**Re: Data Request #10 for the SCE West of Devers Upgrade Project - Application No. A.13-10-020**

# SCE West of Devers Upgrade Project

## Data Request No. 10

**Preliminary Corridor Cross-Section (Segment 4) – 550 kV Structures Replacing 220 kV**

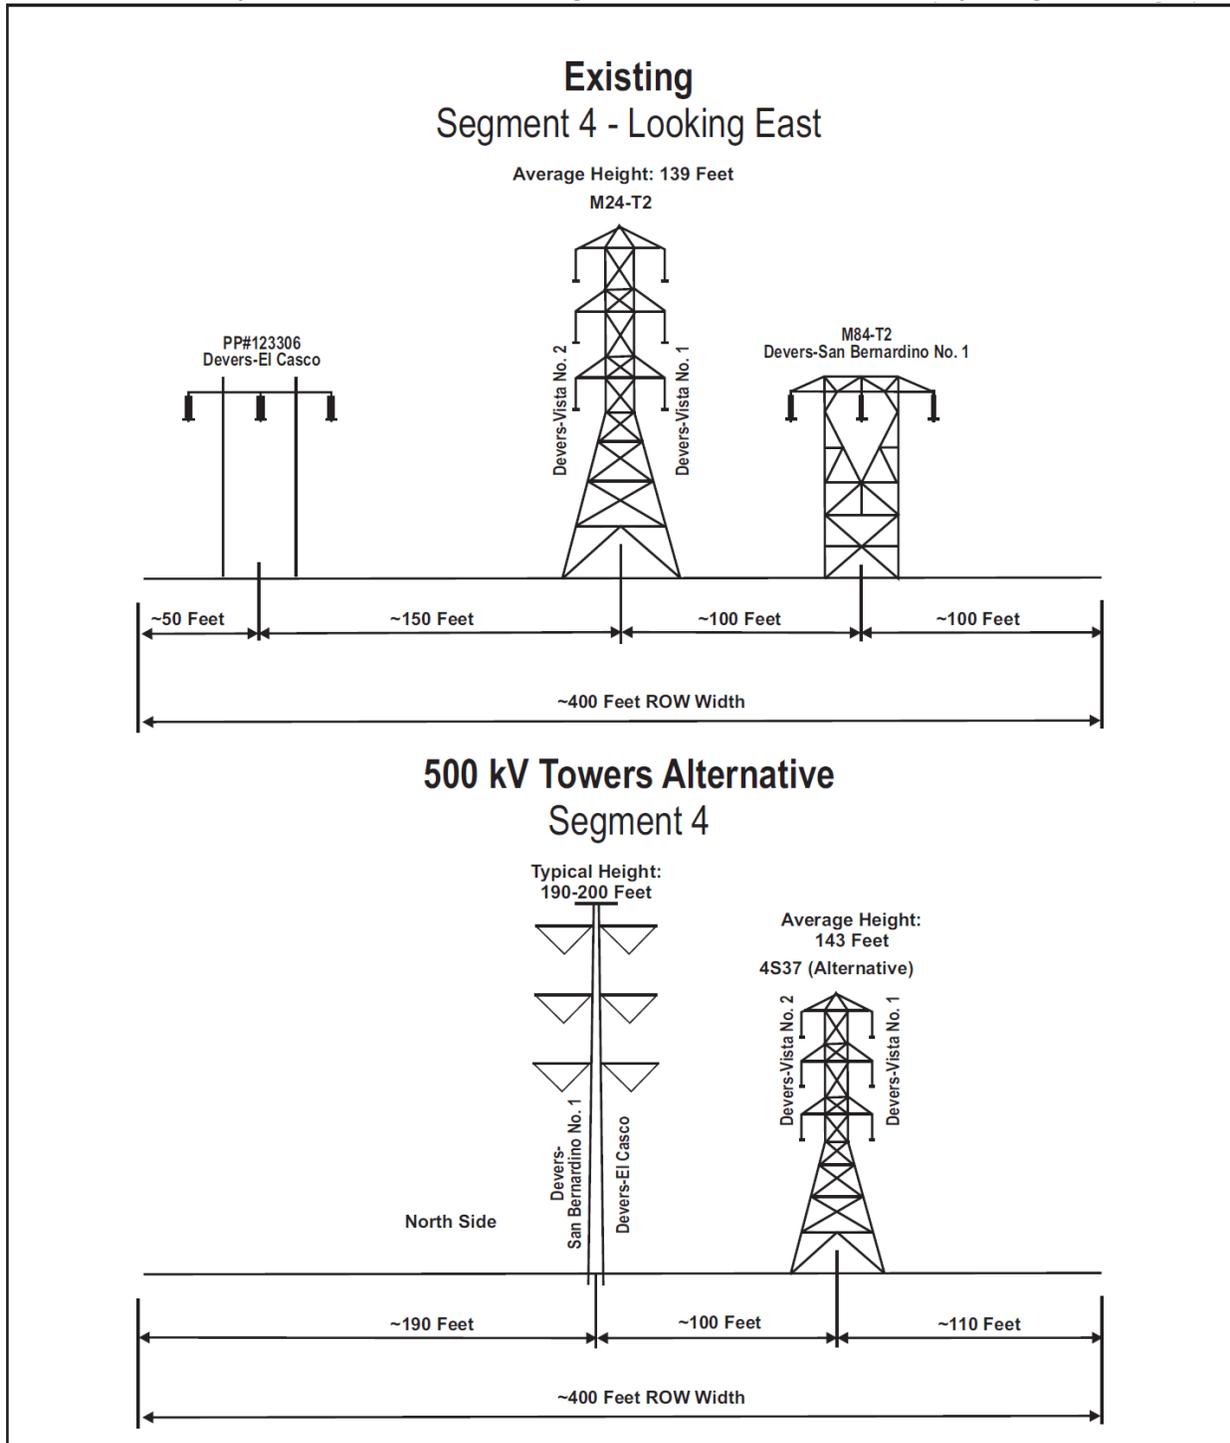
**[No Change from 12/8/14]** Given the general description of the configuration of 220 kV and 500 kV structures shown in the figure on the following page, please answer the following questions:

(A) Please review the preliminary cross-section (presented below), and comment on the assumptions on tower heights and separation of structures.

(B) For 500 kV TSPs to be installed in this corridor, and assuming the structure separation defined in (A) above between the 500 kV line and the new 220 kV structures, what would be the average span length?

(C) Please explain how 500 kV towers could be installed in Segment 2 between San Bernardino Junction and the Vista Substation. Would these towers most likely be installed in SCE's southern separate corridor (currently unaffected by WOD-UP), requiring relocation of the existing 115 kV line currently unaffected by the project?

(D) What potential schedule delays could result from this design configuration? If delays could be longer than the 12 months addressed in ALT-17(E), please describe the specific consequences of the delay. What specific known projects would be affected in terms of their deliverability?

(E) Please describe any other specific feasibility concerns about this design.
